Bulletin No.: 00-06-01-001

Service Bulletin

Subject: Engine Noise (Check/Replace Crankshaft Position Sensor)

**Models: 1999 Chevrolet and GMC C/K Models (Silverado and Sierra)
with 4.8 L or 5.3 L V8 Engine (VINs V, T — RPOs LR4, LM7)
Built within the following VIN breakpoints:**

Crankshaft Position Sensor with Shim Washer

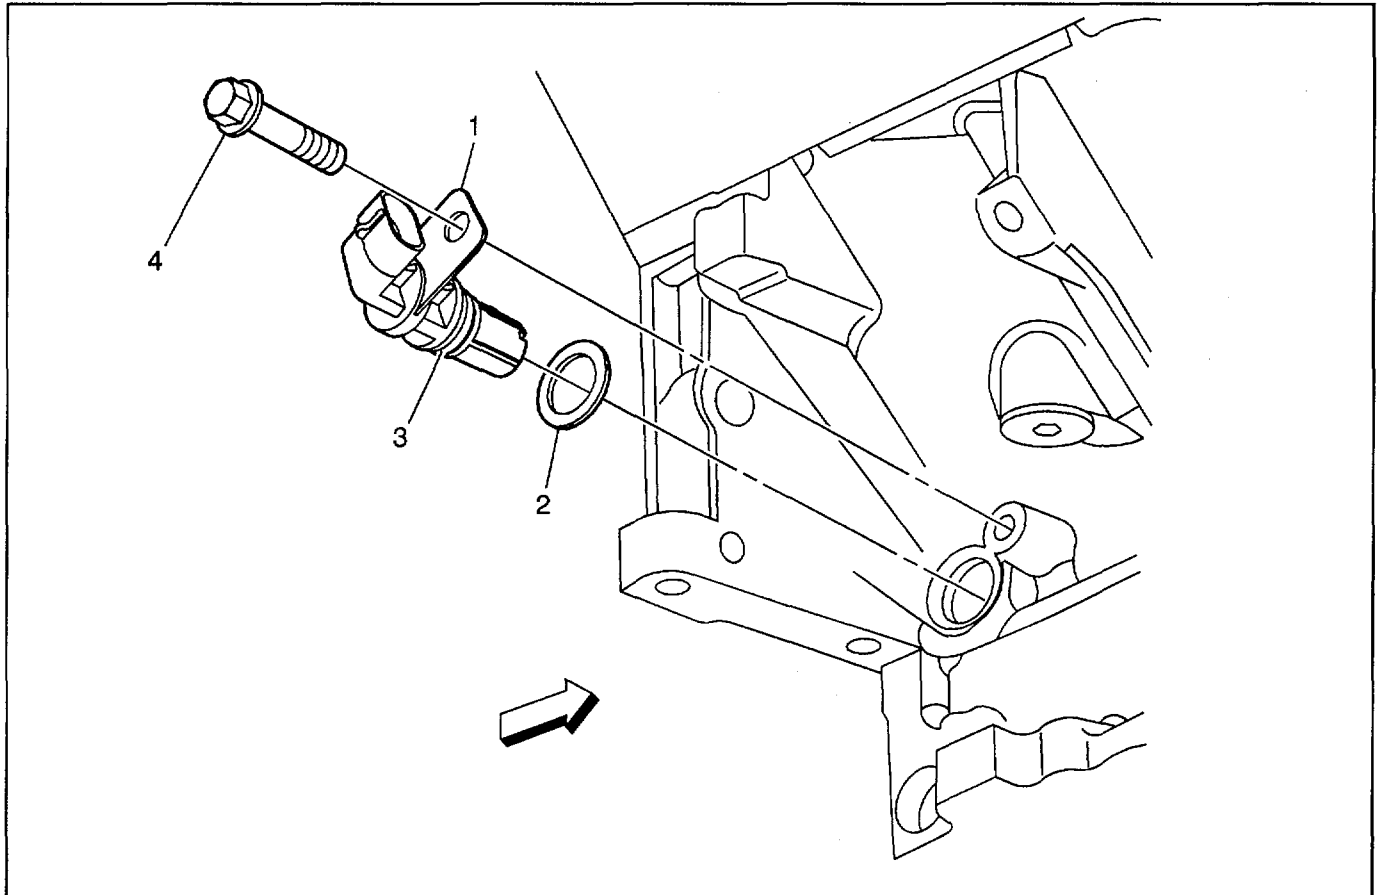
The crankshaft position sensor may be making contact with the reluctor ring.

Important: Dealers may encounter a few vehicles, shipped from the vehicle assembly plants, which have a 2nd rubber O-ring installed over the crankshaft position sensor, and a copper shim under the mounting tab.

1. Remove the crankshaft position sensor (1), and check for witness marks caused by contact with the reluctor ring. Reference the Service Manual procedure as needed.
2. If no witness marks are evident on the crankshaft position sensor (1):

3. If witness marks are evident on the crankshaft position sensor (1):

Important: Do not place an additional shim washer (2) on the crankshaft position sensor (1), if one was not previously installed.

- 2.1. Reinstall the original crankshaft position sensor (1) with any O-rings and shims that may have been previously installed.

Tighten the mounting bolt (4) to 25 N·m (18 lb ft).

- If a shim washer and/or O-ring had been previously installed:
call Technical Assistance for additional instructions.
- If a shim washer and/or O-ring is not present:
 - 3.1. Place a shim washer (2) P/N 12565102 on a new crankshaft position sensor.
 - 3.2. Install the new crankshaft position sensor (1) with the mounting bolt (4).

Tighten the mounting bolt to 25 N·m (18 lb ft).

- 3.3. Perform the Crank Angle Sensing Error (CASE) re-learn procedure.
- 3.4. With the engine at operating temperature, verify the correction of the noise condition.
